TECHNICAL BULLETIN

429-11-21  
14 December 2011

**MODEL AFFECTED:** 429

**SUBJECT:** **SLIDING DOOR SWITCH IMPROVEMENT AND RELOCATION OF**

**Figure 1 Sliding Door Retrofit Kit**

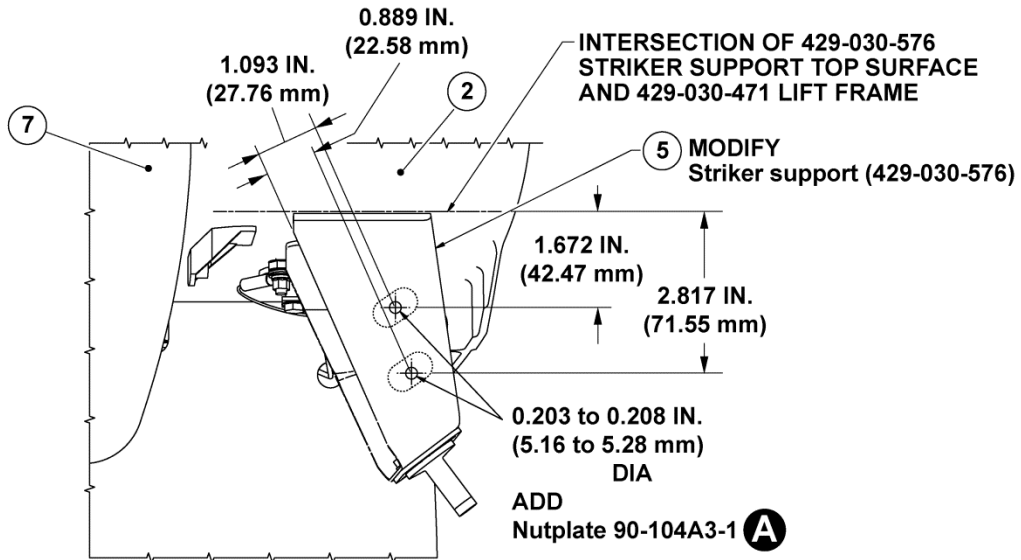
- a. Gain access to frame cover (1, Figure 1 view A). Remove and retain frame cover and screws.
  - b. Gain access to striker support (5, Figure 1 view A). Remove old switch (12), door switch bracket 429-075-537-101, decal 31-065-5270S3 and all hardware.

- c. Refinish qty (2) redundant holes in striker support (5, Figure 1) as per BHT-ALL-SRM, Chapter 3, section 3-2-14, brush chemical film application with 2 coats of primer.

- d. Locate, remove and discard bonded nutplate (Figure 1 view A) as per BHT-ALL-SRM, Chapter 3, section 3-2-22. Refinish reworked area as per BHT-ALL-SRM, Chapter 3, section 3-2-14, brush chemical film application with 2 coats of primer.

3. Locate and mark position of bracket (3, Figure 1 view A and section F-F). Measurement of 1.19 inch (30.2mm) is taken from inside of side body.
  4. Bond new bracket (3) on to frame (2) as per BHT-ALL-SPM, Chapter 7.

**Figure 2 Sliding Door Retrofit Kit**

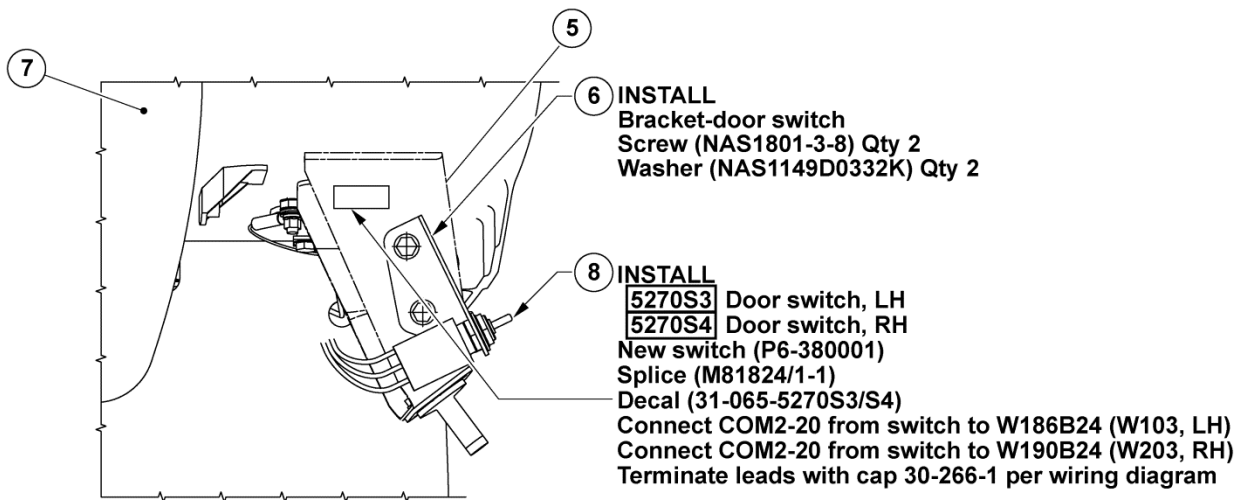
- e. Locate and drill holes in striker support (5, Figure 2 Striker support modification).
  - f. Install qty (2) nutplates 90-104A3-1 as per BHT-ALL-SRM, Chapter 3, section 3-2-21.

- g. Install door switch bracket (6) and all hardware as per (Figure 2 view B).
  - h. Install new door switch (8) and decal 31-065-5270S3 to door switch bracket (6) as per (Figure 2 view B).

**Figure 3 Sliding Door Retrofit Kit**

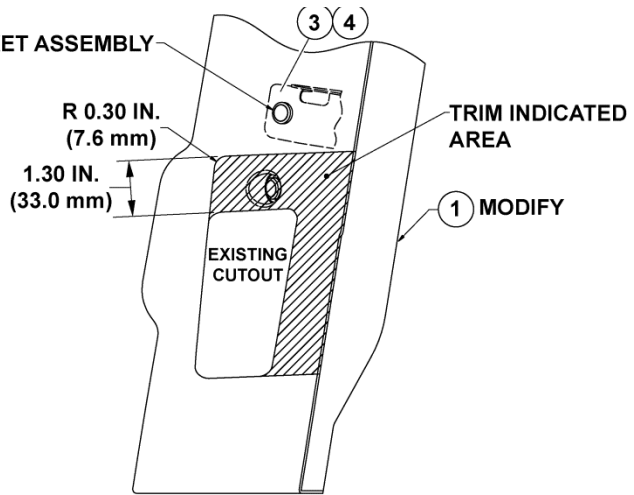
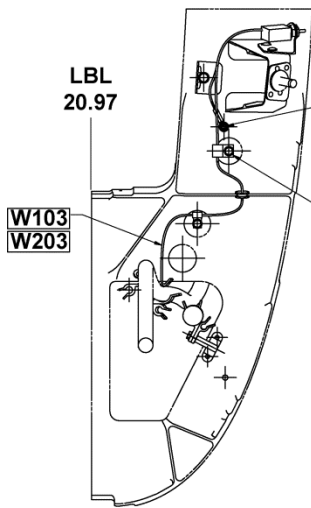
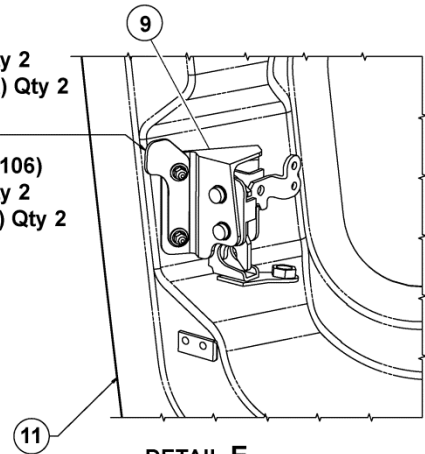
2. Re-route and re-wire new door switch (8) as per (Figure 3 view D and wiring diagram, Figure 4).
    - a. Disconnect ground wire from ground stud and retain hardware.

5. Locate lower aft door latch (Figure 3 detail E). Remove and discard screws NAS 5319V3A5 and washers NAS1149DO332K.
    - a. Install new striker (10) and all hardware as per (Figure 3 detail E).

6. Modify frame cover (1) as per Figure 3, detail C.
  7. Reinstall frame cover (1) with screws PS10F8DS35GY.
  8. Adjust door striker (10) as per BHT-429-MM, Chapter 52.

REPLACE EXISTING CLAMP WITH  
 Clamp (MS21919WDG4)  
 Screw (NAS1801-3-7)  
 Washer (NAS1149D0316J)

REMOVE AND DISCARD  
 Screw (NAS5319V3A5) Qty 2  
 Washer (NAS1149D0332K) Qty 2

ADD 10  
 Striker (429-075-537-105/-106)  
 Screw (NAS5319V3A6) Qty 2  
 Washer (NAS1149E0332P) Qty 2  
 REINSTALL  
 Nut (MS21043-3) Qty 2
